Our Ref: Ohura Water Take S92 – RFI Response

RESOURCE CONSENT APPLICATION NO. APP-2001009379.01 OHURA MUNICIPAL WATER ABSTRACTION

Table 1: Response to s.92 request for further information

Appendix 1 – SCADA Schematic for the Ohura WTP

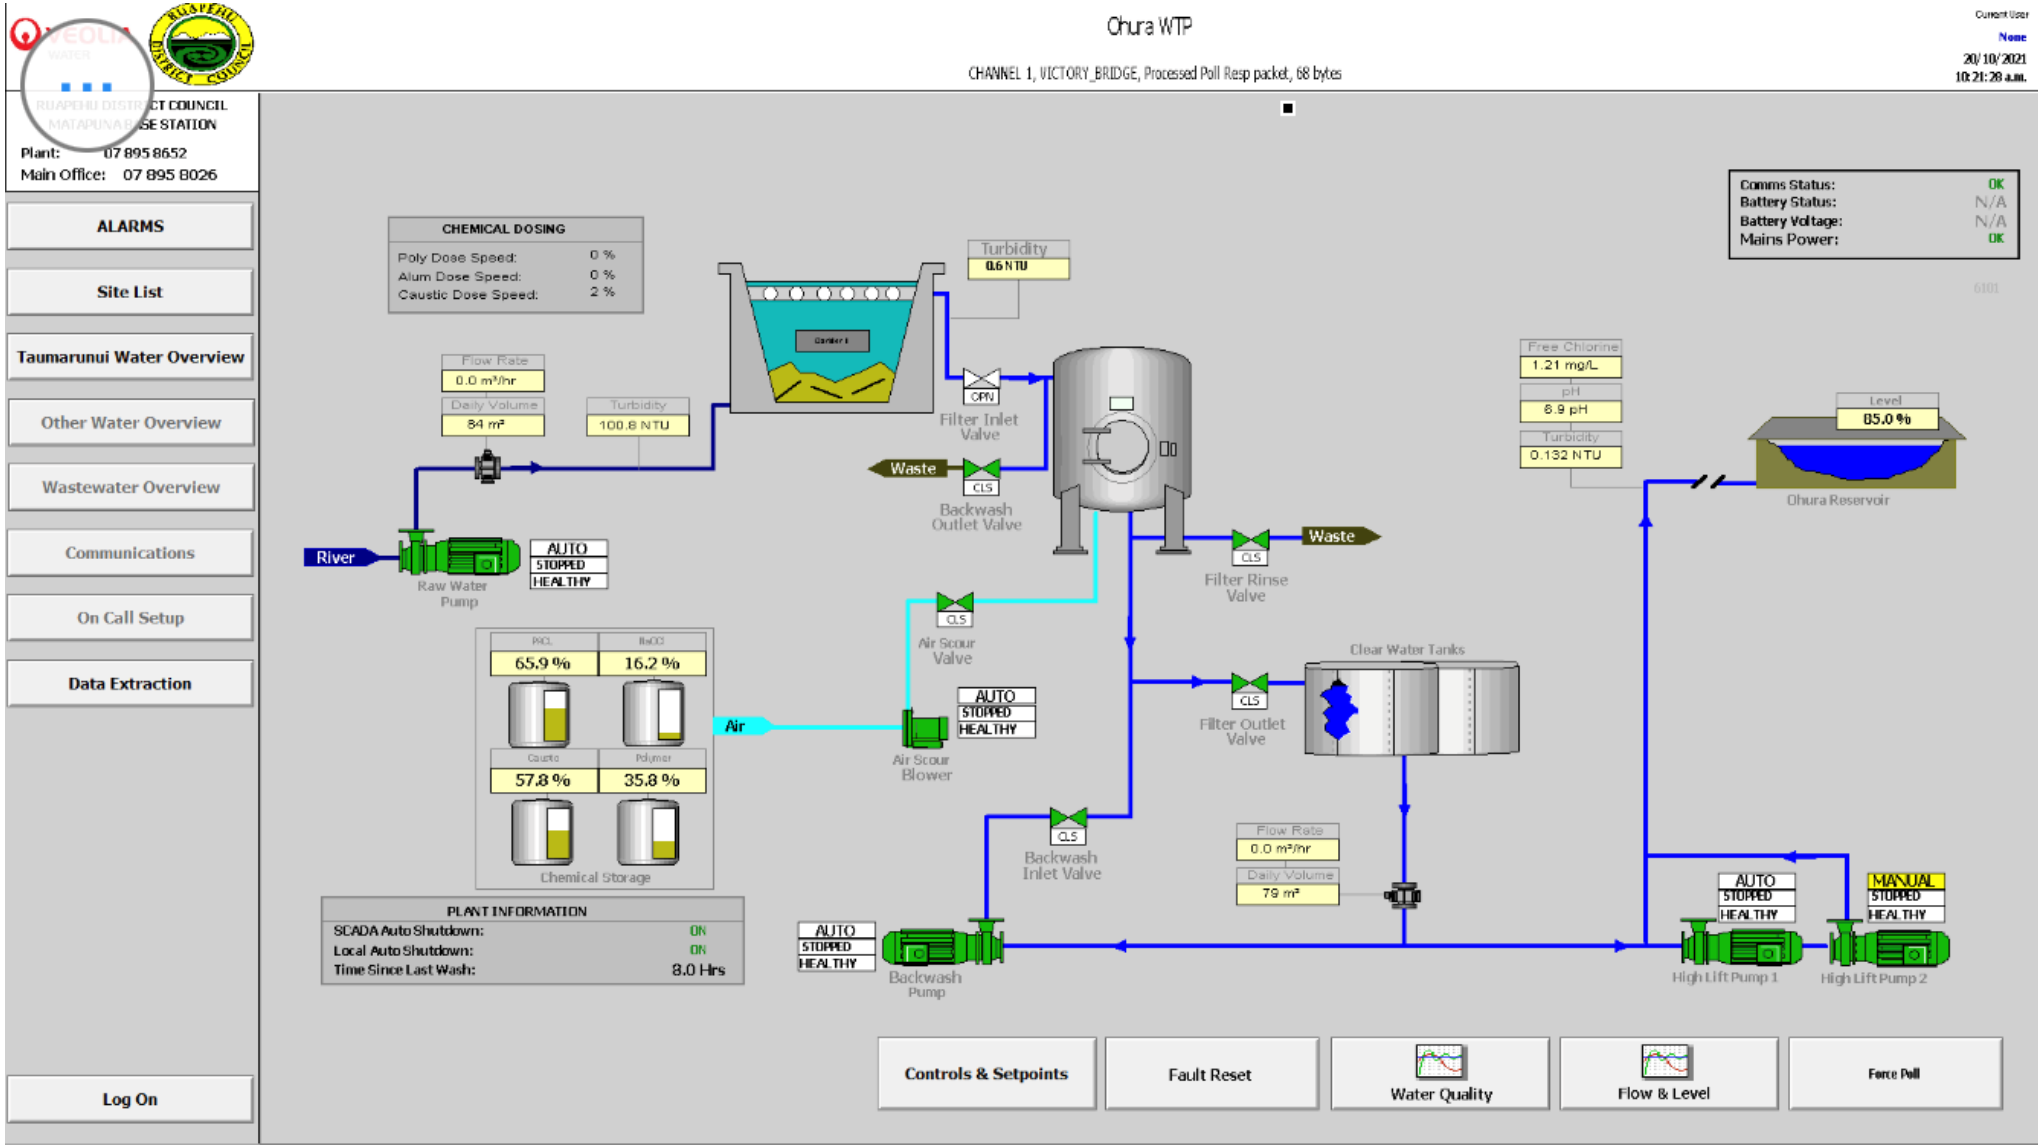
<p>2 <i>Please provide a diagram and explanation of how the flow metering is set up in terms of the two take locations, measuring device locations, outflows and inflows. At present it is unclear where the water use data is recorded and if the second take location is included.</i></p>	<p>As above, RDC confirm there is only one intake. Appendix 1 includes the schematic from SCADA.</p>
<p>3 <i>Please provide a more detailed breakdown regarding how the system is operated day to day. Currently it appears that the plant is only used during the day and turned off at night. The application seeks 15m³/hour over 24 hours but if it is only being used for 10 – 12 hours then abstracting this volume is not possible at that that hourly rate.</i></p>	<p>Currently the WTP runs on reservoir demand/set points as a result of limited ability at the current plant to store water. The current reservoir is only 286m³ and operates between 75 and 95%. This creates run times and requires that abstraction is timed with demand to ensure there is always sufficient supply available to meet demand as it occurs.</p>

Appendix 2 – Abstraction Discrepancies

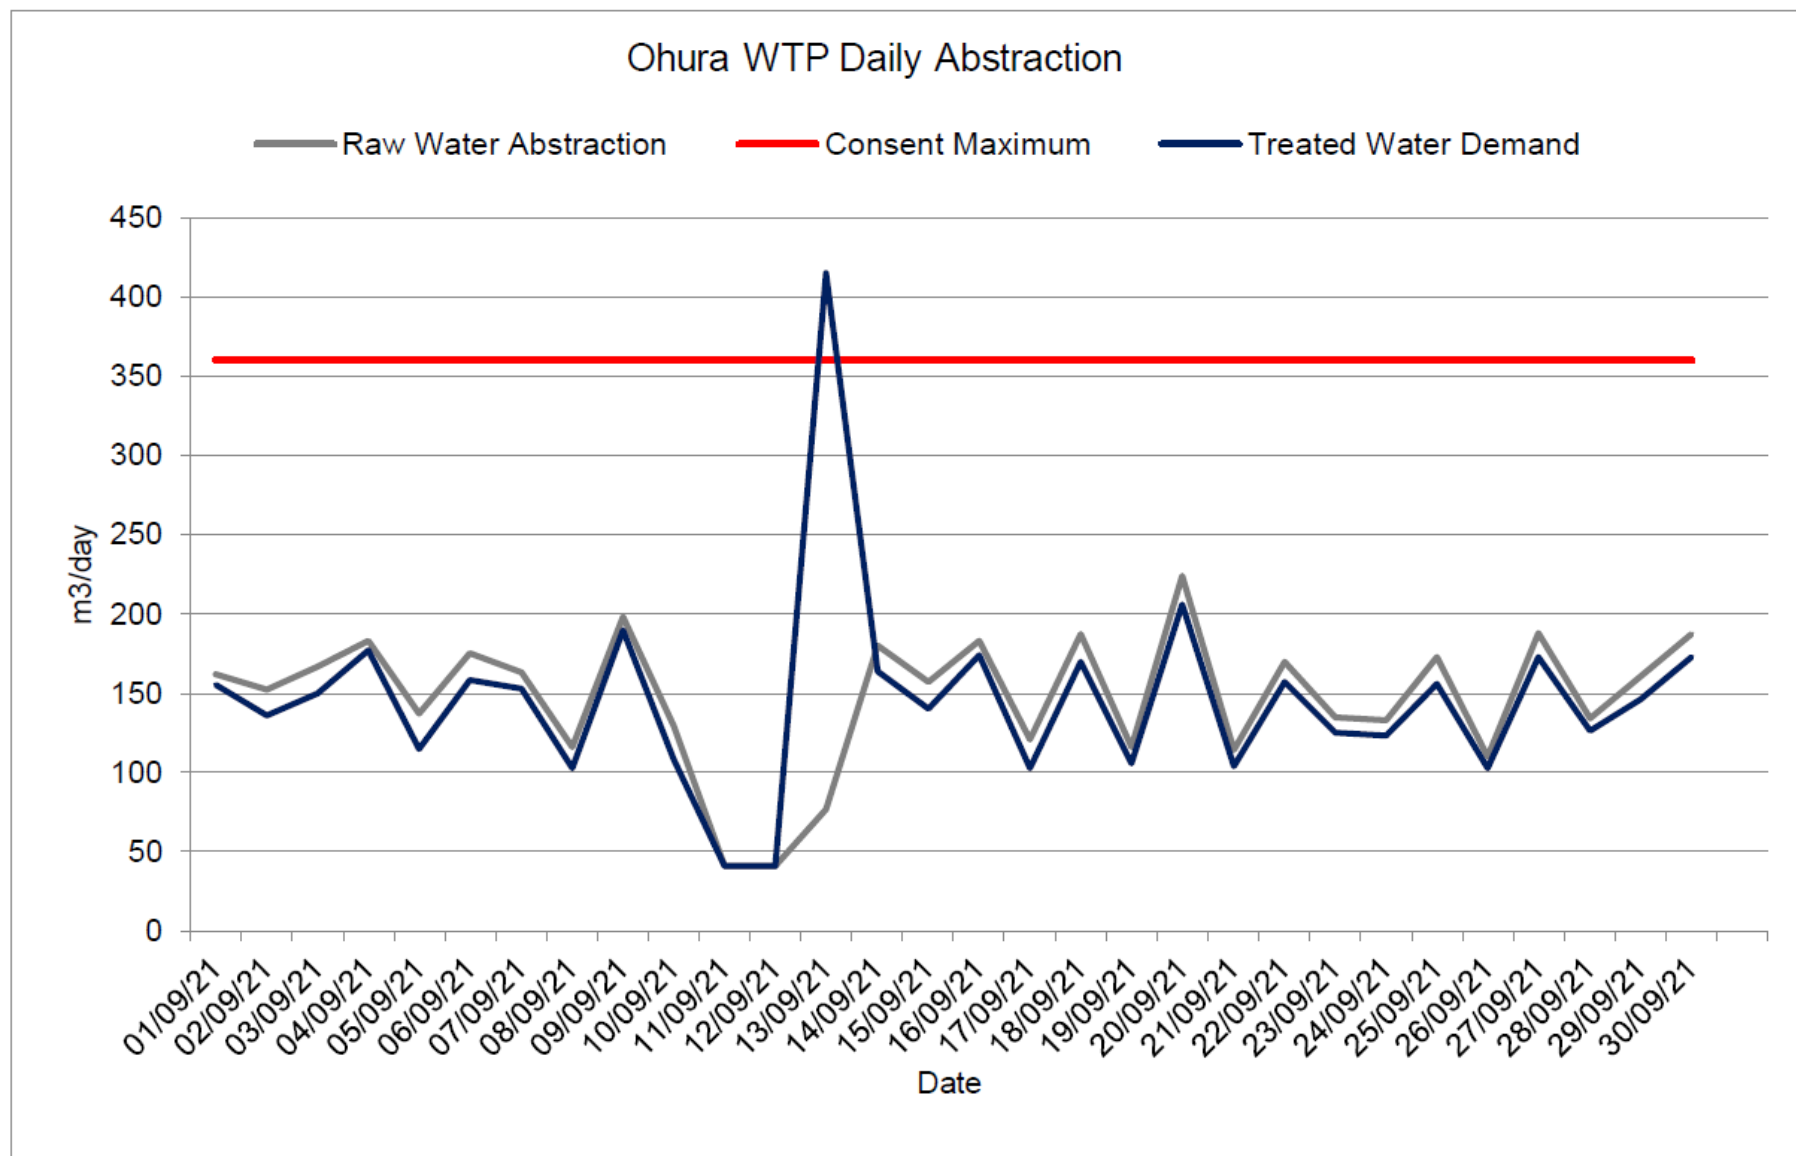
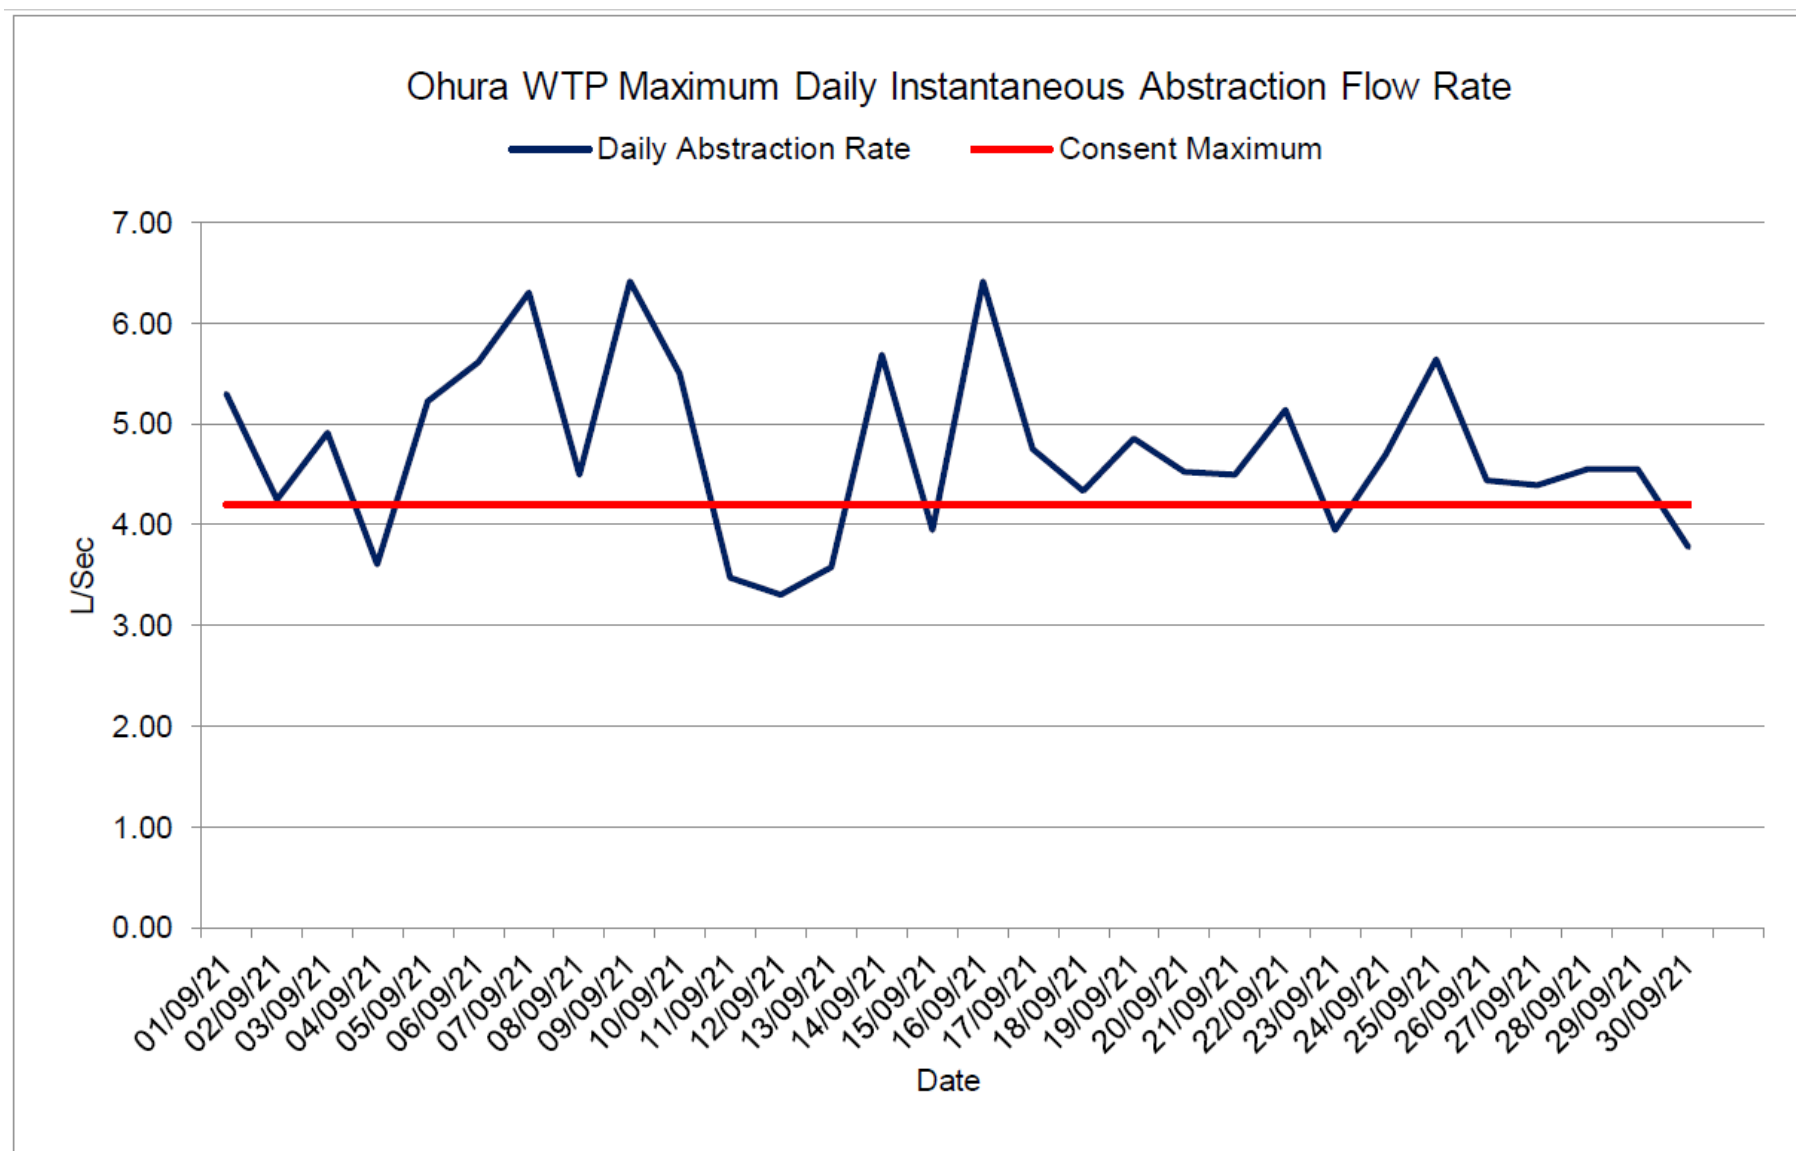
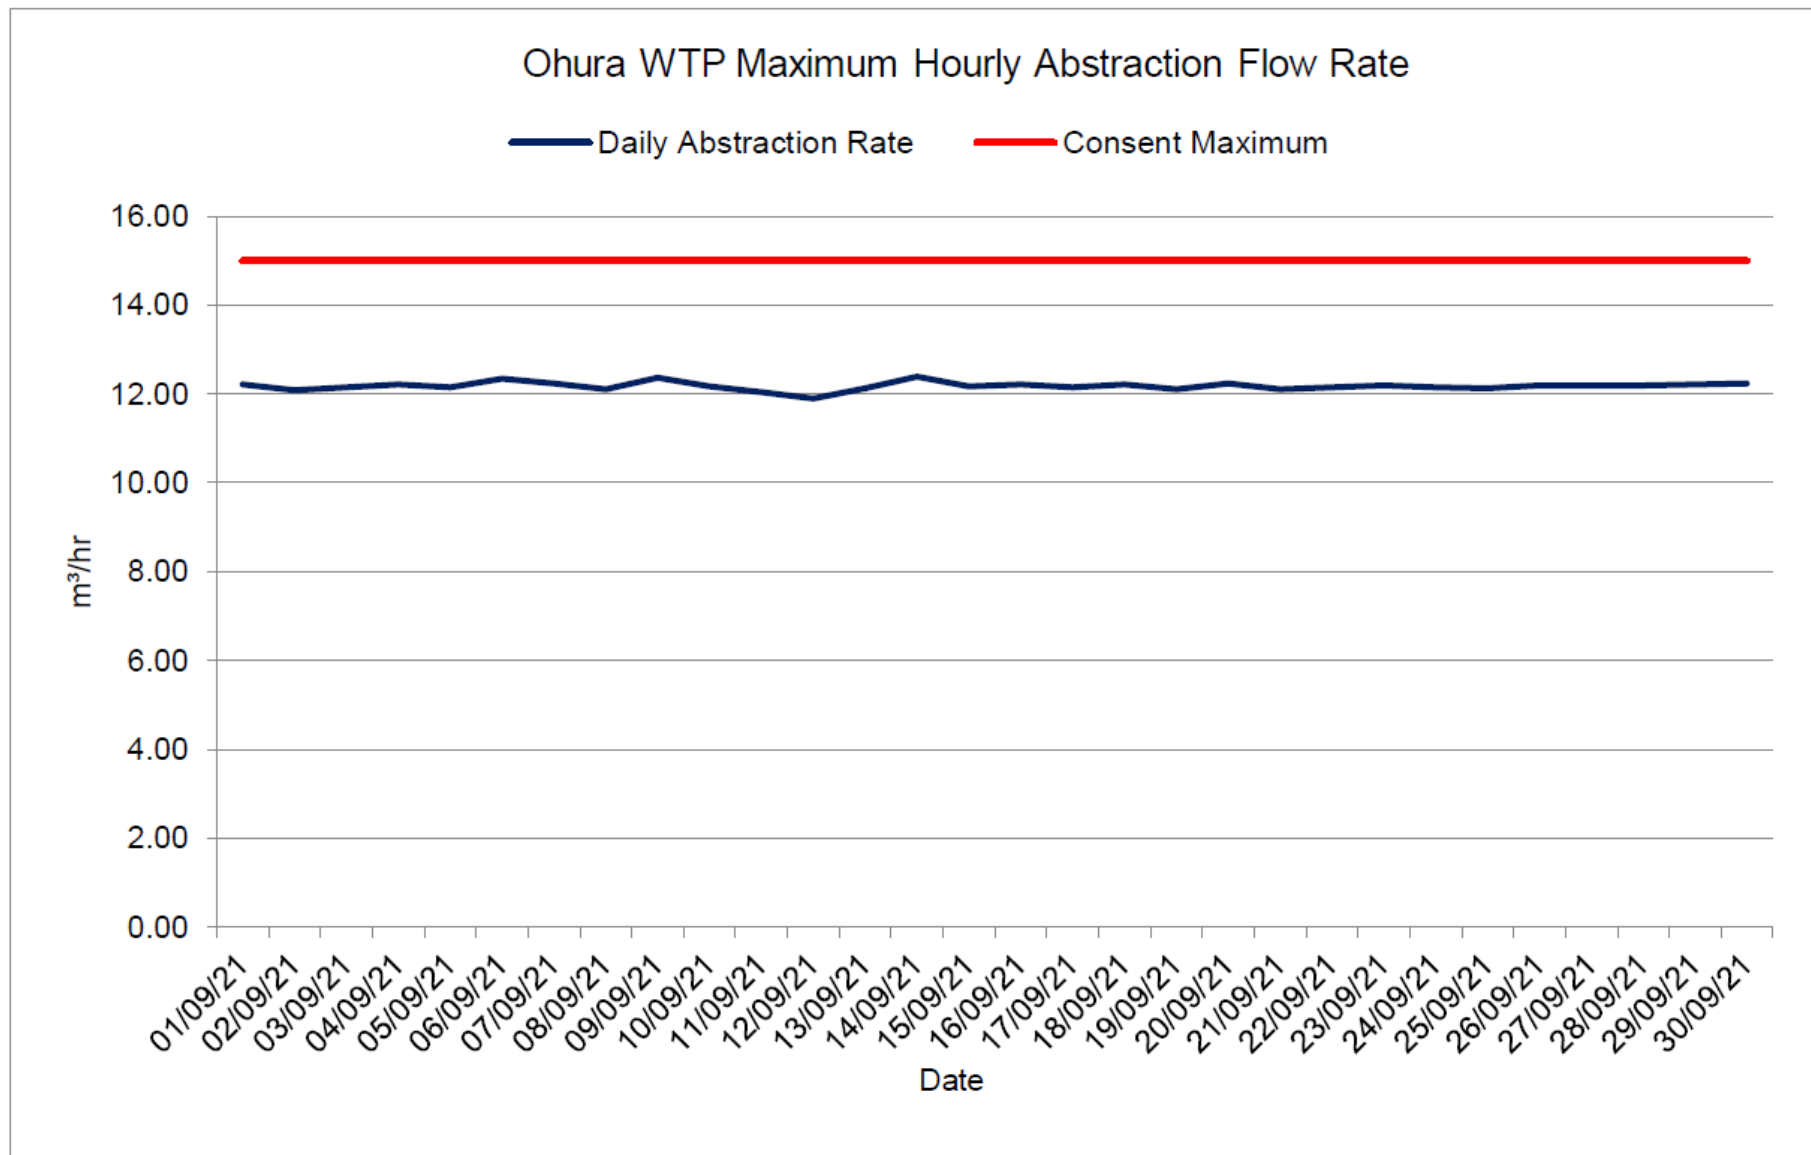
Horizons Information Request / Comment		RDC response
		A larger reservoir (500 m ³) is being proposed which will allow for more prolonged run times as there will be greater buffer. This would also result in longer downtimes between plant runs.
4	<i>It has been identified that when abstraction commences and ceases, spikes in the rate of take occur. Has the new pump rectified this situation?</i>	<p>A new pump and associated pipework has been installed but intermittent spikes do still occur. Because the pump is at the WTP rather than the intake, it operates as a vacuum and therefore air is possible in the line. These spikes in flow rate are often only recorded for 1-2 minutes. We are looking to operate a 'clip on' flow meter for a period to monitor if the issue is with the flow meter (which recently passed 'blue tick' verification). See graphs attached as Appendix 2 showing abstraction discrepancies.</p> <p>From these graphs, it can be seen that the plant is compliant with abstraction, apart from the maximum in L/sec. Veolia are confident this is an anomaly in the reading rather than genuine exceedance and continue to investigate further.</p>

Ignoring the spike (Due to SCADA outage), daily abstraction is always below consented value.

This shows the maximum abstraction rate in L/sec for each day. SCADA records minute data for flow in m³/hr then it is converted to litres/sec in excel. Even if the spike is for one minute then it will record as a failure.

This shows the maximum abstraction rate in m³/hr for each day.

Figure 1. Habitat suitability/preference curves for upland bully, crans bully and longfin eel. Habitat preference curves were taken from Jowett & Richardson (1995)³, who assessed the habitat preferences of common, riverine New Zealand native from the assessment of 34 different rivers and streams.

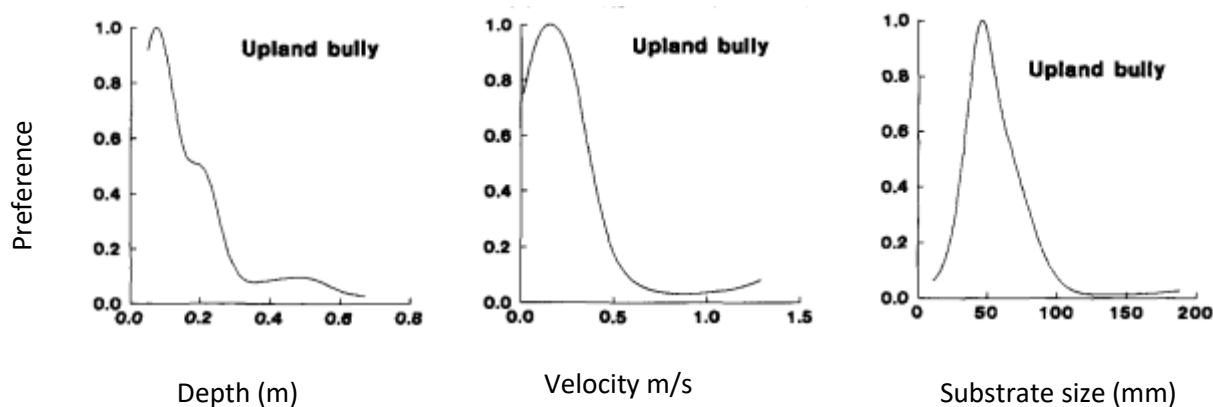
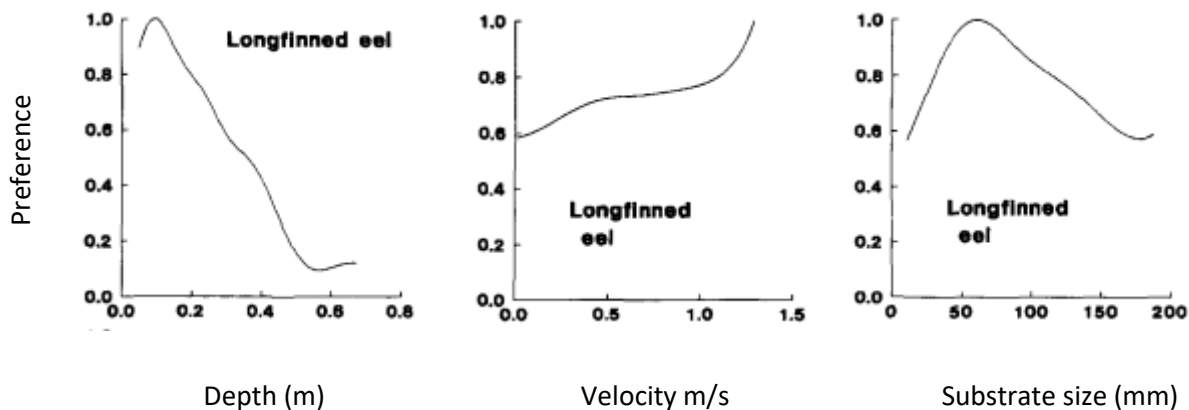
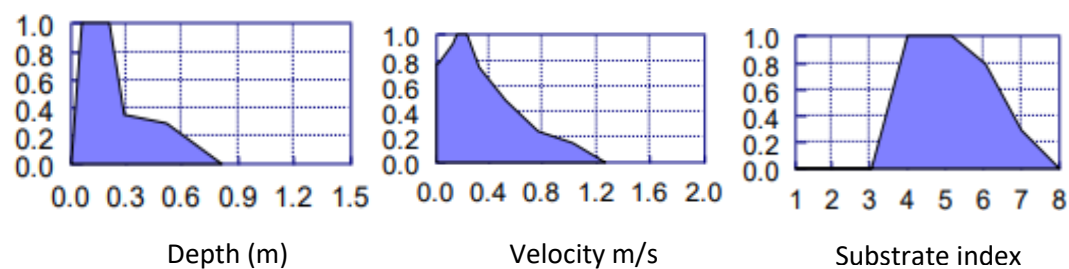
From 6 years, the minimum flow take is still going to be approximately 17% of MALF in the Mangaparare Stream. Please detail what the ongoing environmental effect of this will have on Schedule B values like life supporting capacity or other values (through things like available habitat, temperature, dissolved oxygen, etc.)?

Habitat preference (suitability) curves, which describe the physical conditions (depth, velocity, and substrate size) in which organisms are found, were examined for longfin eel and the two bully species extant in Mangaparare Stream to assess the likely changes in habitat availability from changes in flow (Figure 1).

Depth. The depth preference curves for all three fish species significantly increased with decreasing depth (NB: the very steep curves) (Figure 1). The optimum depth for all three species was ~10cms. During the March 2021 fish surveys and flow gauging, mean stream depth at the downstream site was 45cms and the upstream flow was 11 ± 2.3 L/s (i.e., equivalent to MALF (12 L/s)²). Thus, any effects from an abstraction rate of 17% of MALF (approx. 2 L/s) are likely to be negligible. If there are any effects, they are likely to be towards more, rather than less, suitable habitat for the three fish species extant in the Mangaparare Stream.

Velocity. The two bully species have an optimum velocity of approx. 0.2m/s. Habitat preference rapidly declined in velocities above 0.2 m/s, while below 0.2 m/s habitat preference remained relatively high (Figure 1). Long fin eels have an optimum velocity above 1 m/s. However, the suitability curve remains rather 'flat' between 0.1m/s and 1m/s indicating only minor changes in habitat preference in this range.

Estimated reduction in mean velocity downstream of the intake due to a take of 2 L/s from a MALF of 12 L/s is between 2 mm/s and 11 mm/s, assuming all the effect of less flow manifesting as change in mean velocity. In reality, there would be a small decrease in wetted area too, meaning that the reduction in mean velocity would not be as great as stated. For the species present, the effect of a 2-11 mm/s change in velocity, on habitat preference of such a small reduction in mean velocity is negligible.
